CITY of NOVI CITY COUNCIL

Agenda Item J
July 23, 2012

SUBJECT: Approval of the request of Singh Construction Company for Final Plat approval for Phase III of the Tollgate Woods Subdivision. The subject property is part of the Vistas Planned Unit Development, located between Novi Road and Meadowbrook Roads and south of Thirteen Mile Road in Section 11.

Tollgate Woods, Phase III Subdivision Final Plat
SP #12-07A

LIBER _____ PAGE _____
SHEET 3 OF 10 SHEETS

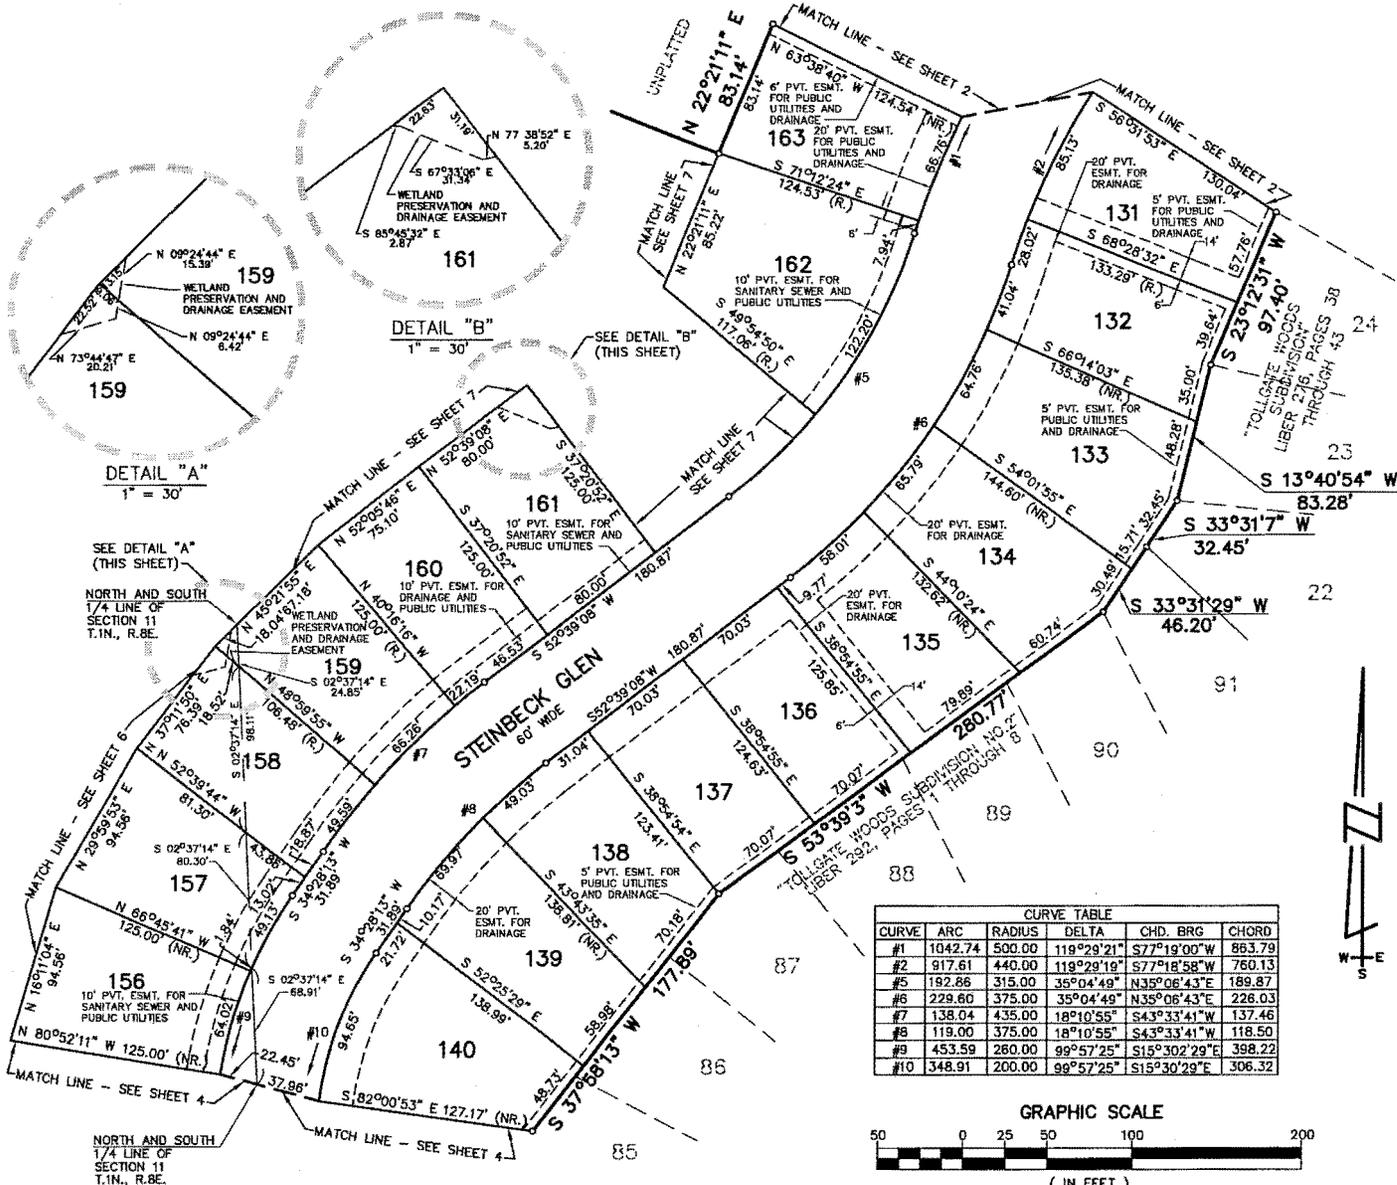
However, the Final Plat does NOT appear to contain the necessary wetland and Conservation easement boundaries associated with the following lots:

- Lots 158, 159, 161 and 162 (Sheet 3 of 10);
- Lots 149 and 150 (Sheet 4 of 10);

The lots indicated above contain regulated wetland and/or wetland buffer. These areas do NOT appear to have been incorporated into wetland and/or Conservation Easements on the Plan.

ECT recommends that these Plans be revised in order to incorporate these regulated wetland and wetland buffer areas into an appropriate easement.

The City's environmental consultant (ECT) reviewed the Final Plat and issued a review letter dated June 28, 2012. In that letter ECT noted that the Final Plat did not show the recorded wetland conservation easement on six proposed lots (Lots 149, 150, 158, 159, 161, 162). This easement had been shown on the subdivision engineering drawings approved and stamped in August 2000. The applicant electronically re-submitted a Final Plat on July 17, 2012; Planning staff was able to confirm that the revised Final Plat now shows the conservation easement on the appropriate lots, which satisfies the concerns noted in ECT's review letter.
